Attn: *Laurie Connors, Director*
RE: *Peer Review for Site Development Plan at
192 Millbury Avenue, Millbury, Massachusetts
BEI Project No. 21M-170
Mass DEP File No. 224-0826*

**Peer Review
Millbury Planning Board**

Parcel Identification Number: 23-047
192 Millbury Avenue
Millbury, Massachusetts

(Revised November 17, 2021)

DEP FILE # CERO 224-0826
SHEET 1 OF 3

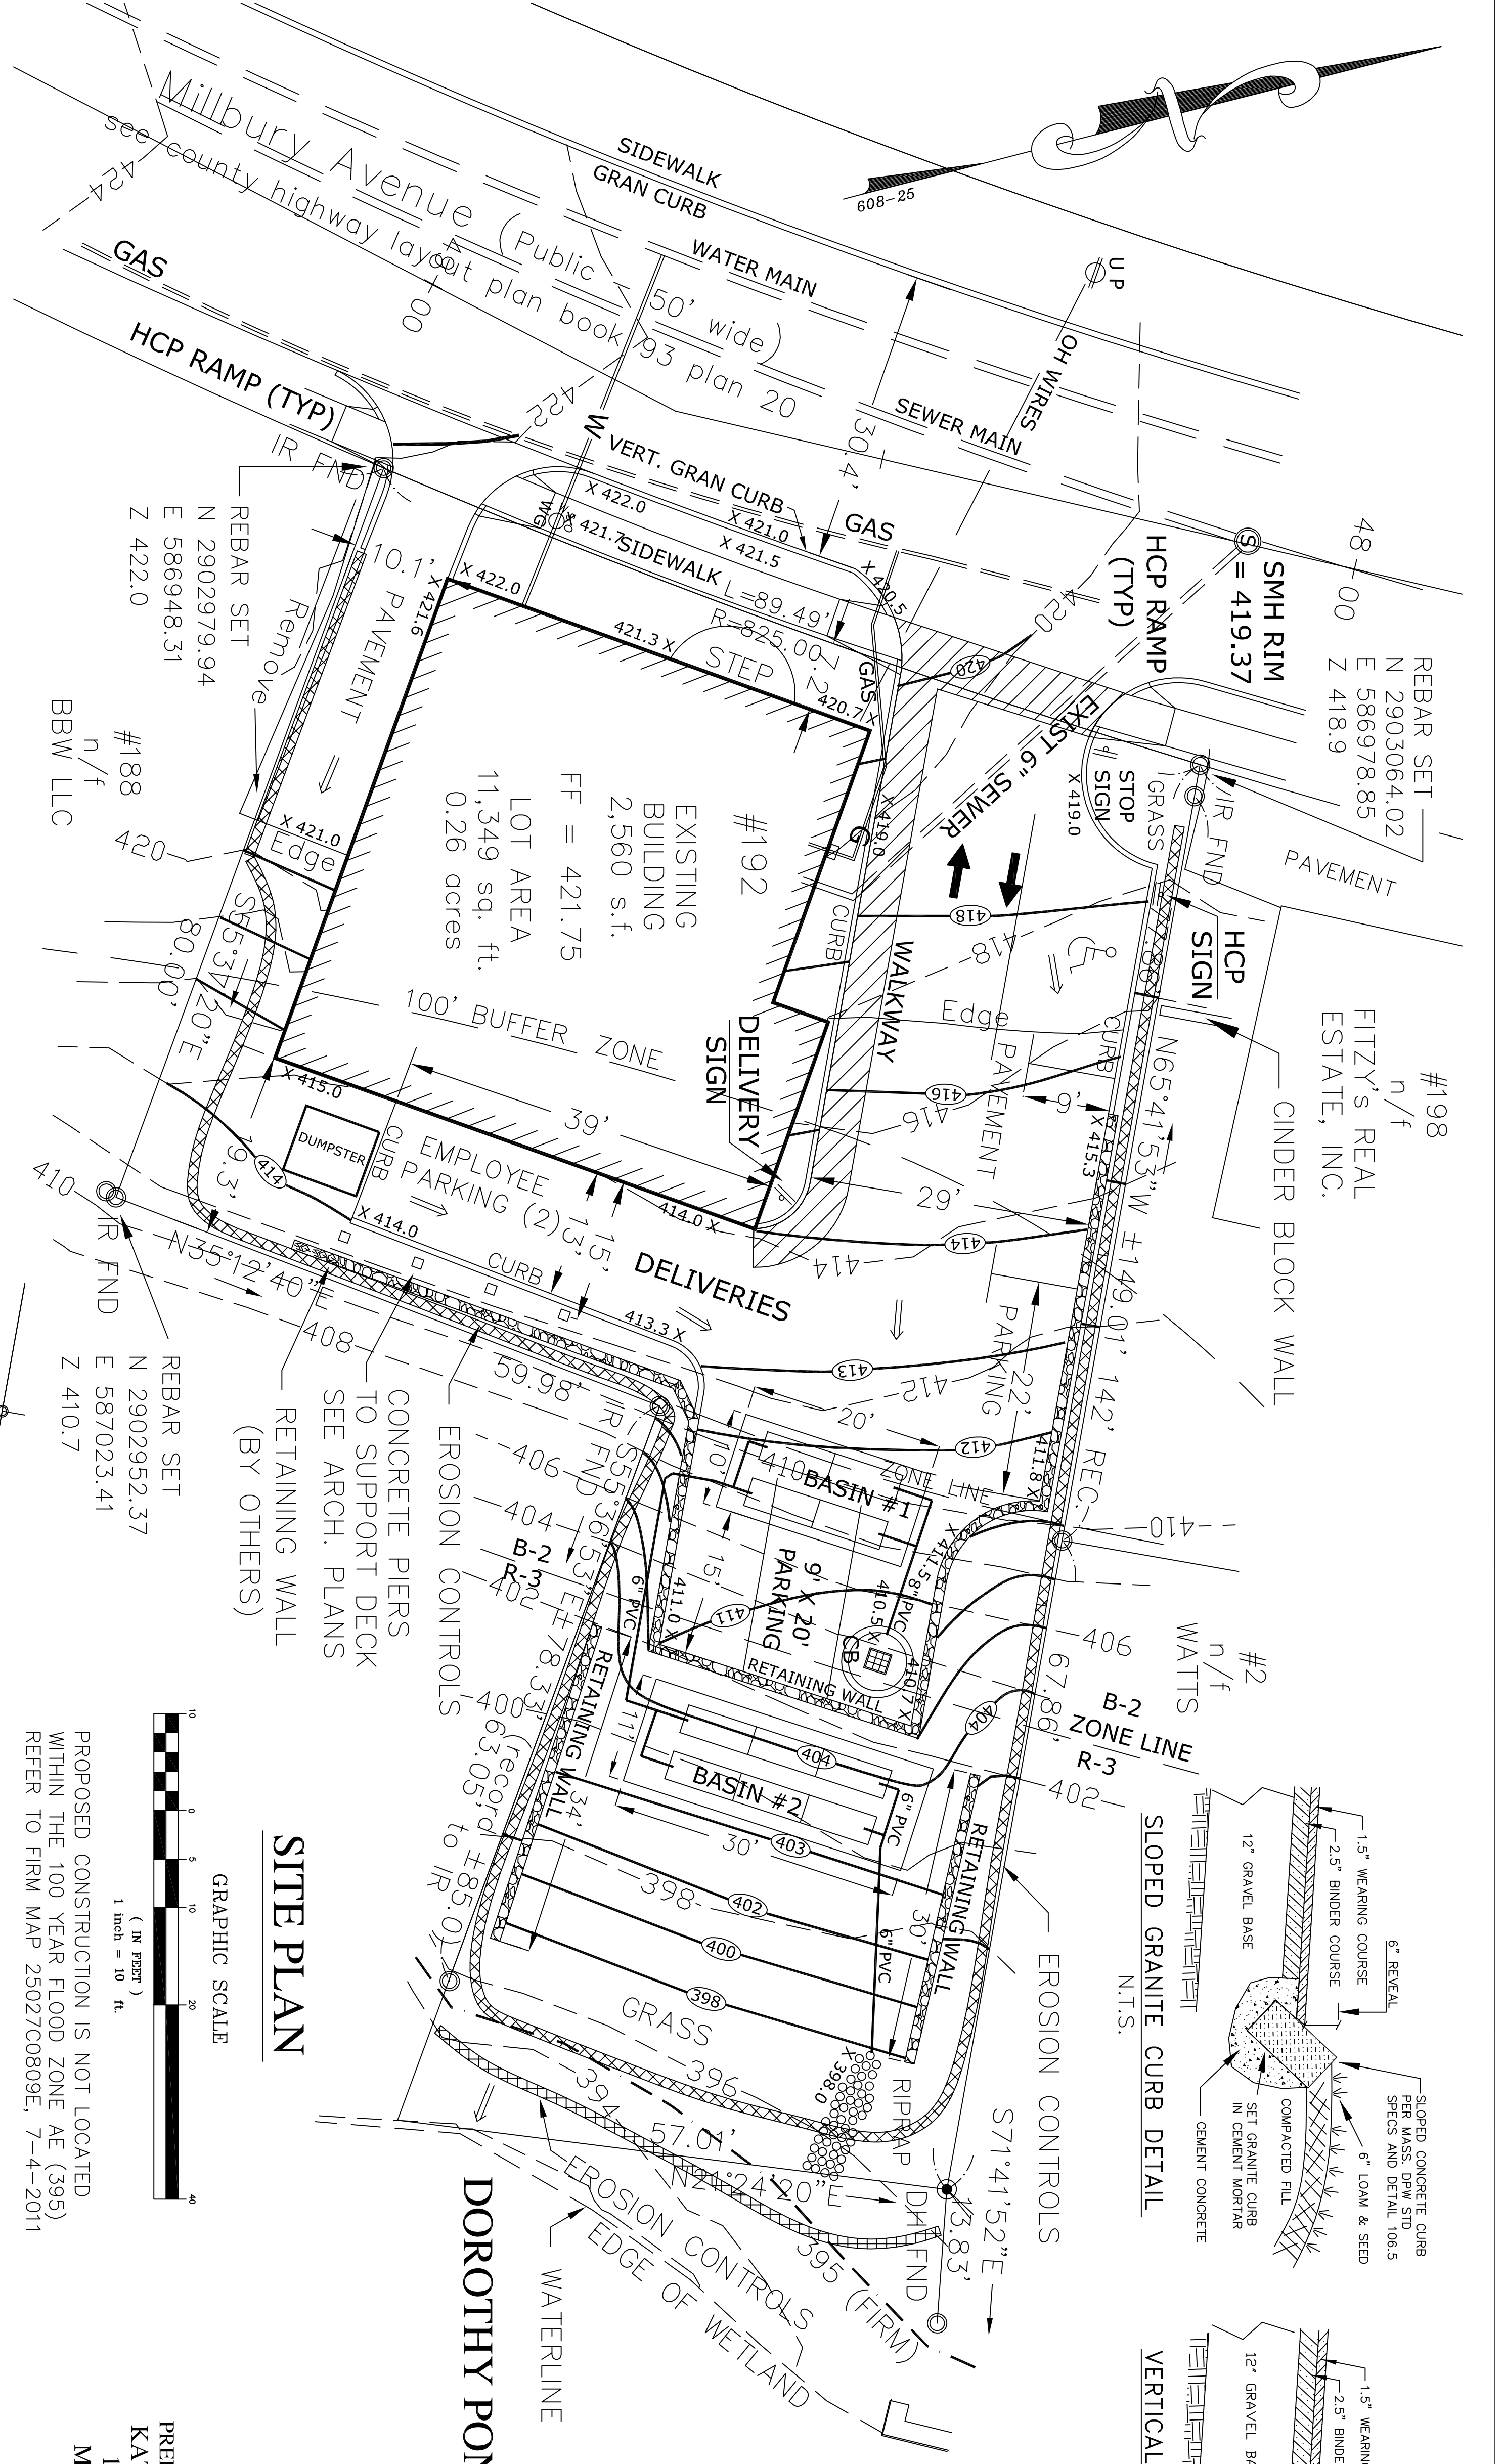
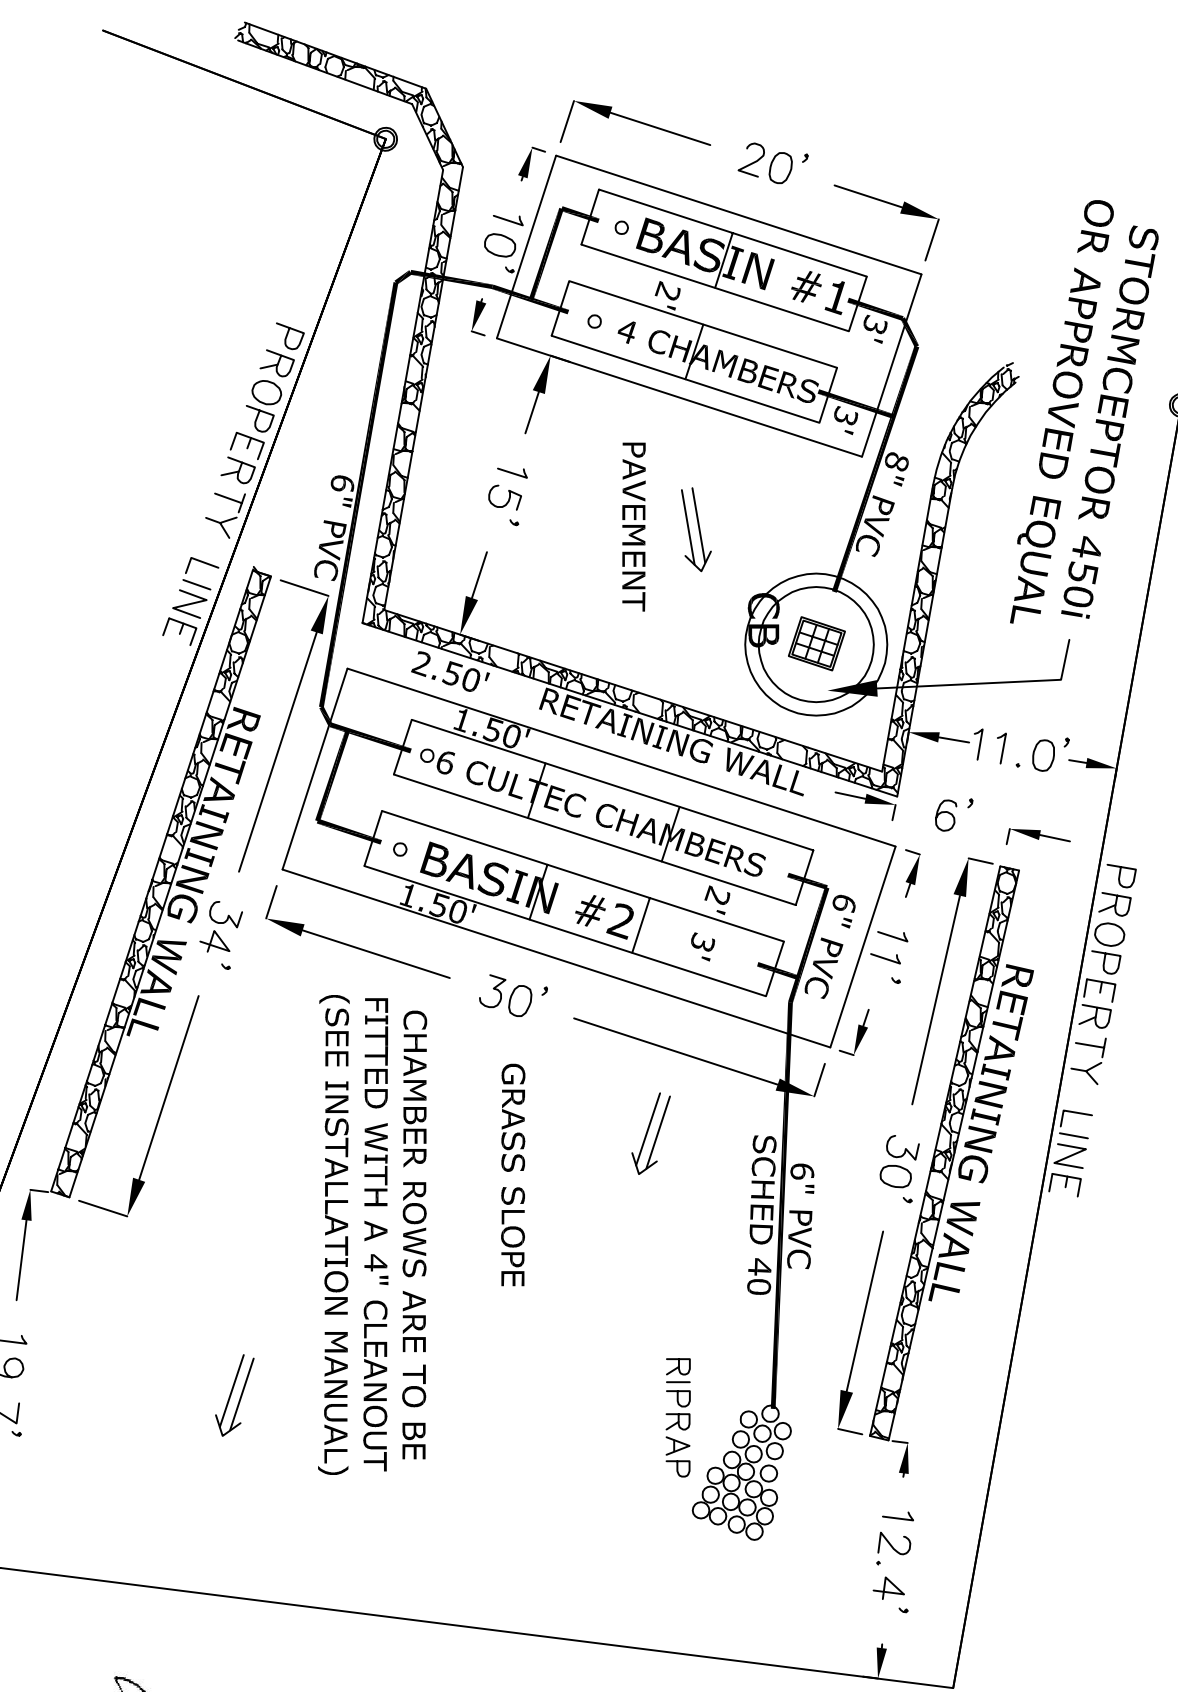
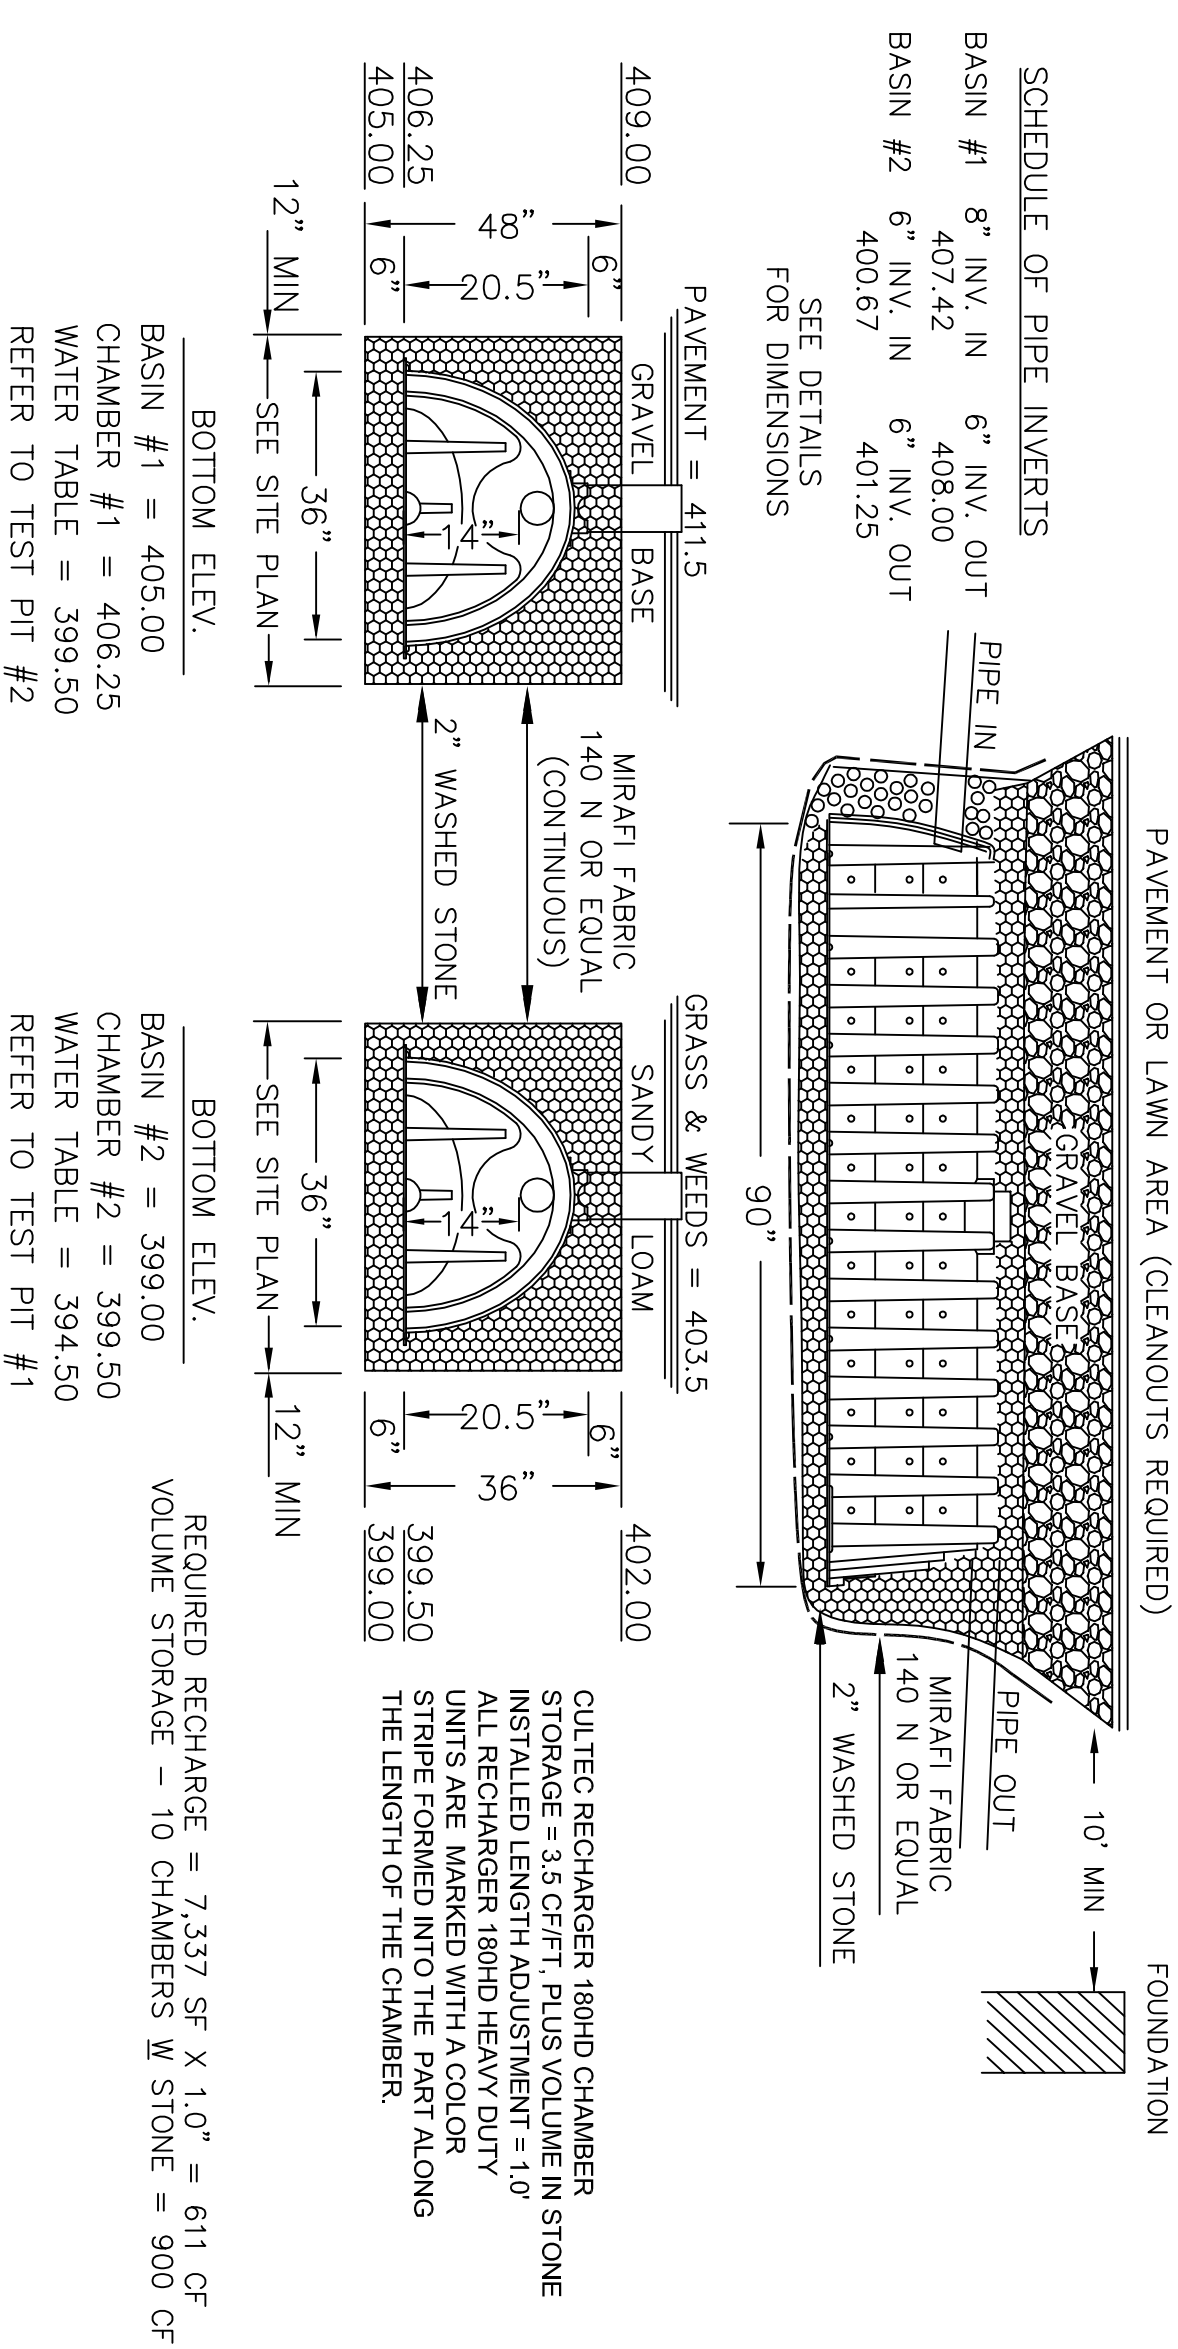
BEI Comment 9: 6.17.4 (a) -All drain pipes shall be at least twelve inches (12") inside diameter, made of High Density Corrugated Polyethylene (HDPE). It is unclear... why the RMA has specified 6 and 8-inch PVC for storm drainage piping on drawing sheet 1 and 2.

1. North Arrow and correct scale in title box be shown on site plan sheet 1 of 3.
2. Construction of the two paved drives off Millbury Avenue will require reconstruction of the existing sidewalk and curbing. We recommend these improvements be further identified on the site plan.
